WASTE ISOLATION PILOT PLANT

SPALLINGS

CONCEPTUAL MODEL

PEER REVIEW REPORT

Figure 3-3: Failure and Fluidization

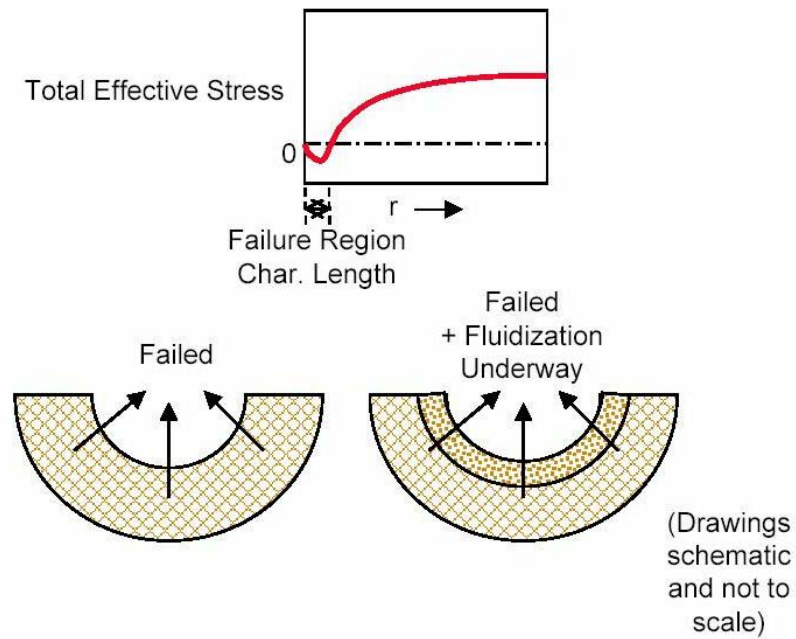
In the numerical implementation, a characteristic length  $L_c$ , that covers several grids (or nodal points) is used to determine the failure zone of the medium. Note that  $L_{fz}$  shown in Figure 3.3 is the length of tensile failure zone which may consist of several characteristic lengths. When the average effective radial tensile stress over the characteristic length exceeds the failure stress  $T_o$ , the particles inside the length are assumed failed. Therefore, the failure zone shown in Fig. 3.3 may contain several characteristic lengths. The characteristic length is an important parameter in determining the size of failure zone and the volume of spalling release. The effect of characteristic length on spalling volume will be discussed in a later section.

The SNL spalling model does not calculate the particle size of the disintegrated material. It assumes that the material disintegrates to particles of the surrogated material (to be discussed later). Since the particle size of the surrogated material is small, the Panel considers that it is an acceptable and conservative approach for simplifying the problem.
